NUMBER: 05-006-16

GROUP: Brakes

Incorrectly Installed Rear Brake Caliper

2016	(DS)	Ram 1500 Pickup
2016	(DX)	Ram Truck (Mexico)

Fig. 1 Incorrectly Installed

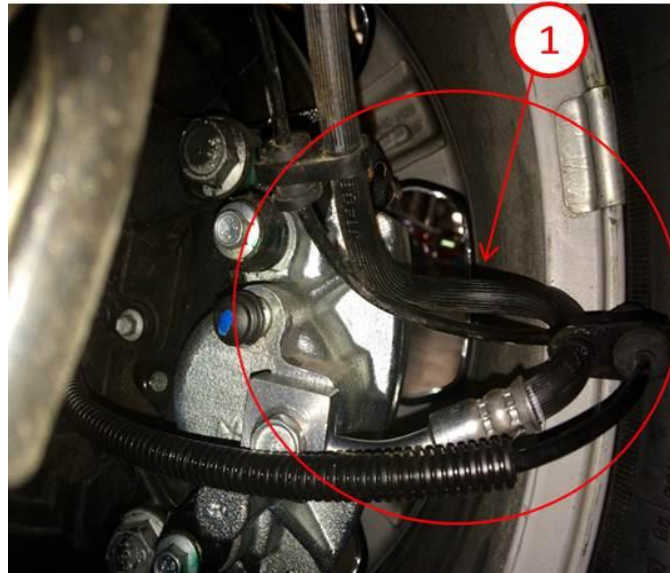
Some vehicles may have been built with the rear brake caliper installed 360° incorrectly onto the caliper adapter mounting bracket.

2. Is either the left or right rear brake hose kinked, twisted or rubbing on the rear axle, ****wheel or tire****?
 - a. YES>>> Proceed to [Step #3](#).
 - b. NO>>> This bulletin has been completed, use LOP (05-30-05-91) to close the active RRT.
3. Does the brake hose show signs of wear or leaking? ([Fig. 1](#)).
 - a. YES>>> Proceed to [Step #4](#).
 - b. NO>>> The brake hose is kinked, twisted or rubbing with no signs of wear. Proceed to [Step #5](#).
4. Replace the rear brake hose, ****banjo bolt(s) and washers**** on the affected side of the vehicle. Refer to 05 - Brakes/05 - Brakes, Base/Hydraulic/Mechanical/Tubes and Hoses, Brake/Removal/Installation.

NOTE: **Discard the old banjo bolt and washers when replacing a brake hose. New washers and a banjo bolt must be used on installation.**

Fig. 2 Correctly Installed

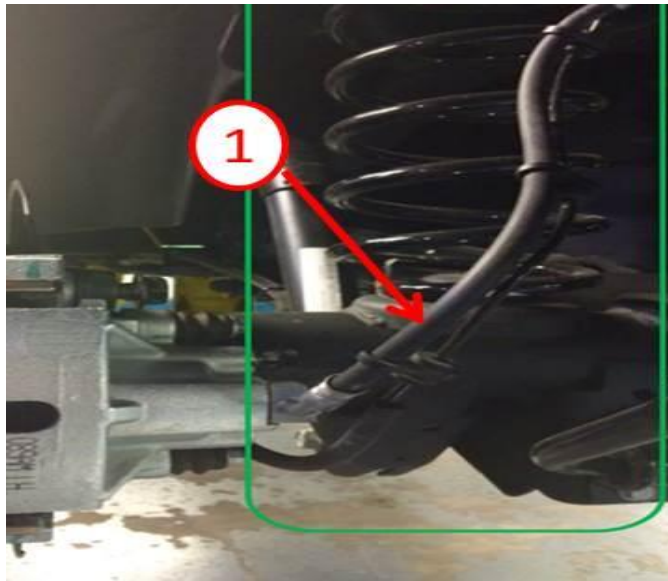
5. Remove the brake caliper from the caliper adapter mount and rotate the assembly 360° and reinstall properly **making sure there is no contact against rear axle, wheel or tire** (Fig. 2). Tighten the brake caliper mounting slide pin bolts to 30 N·m (22 ft. lbs.).
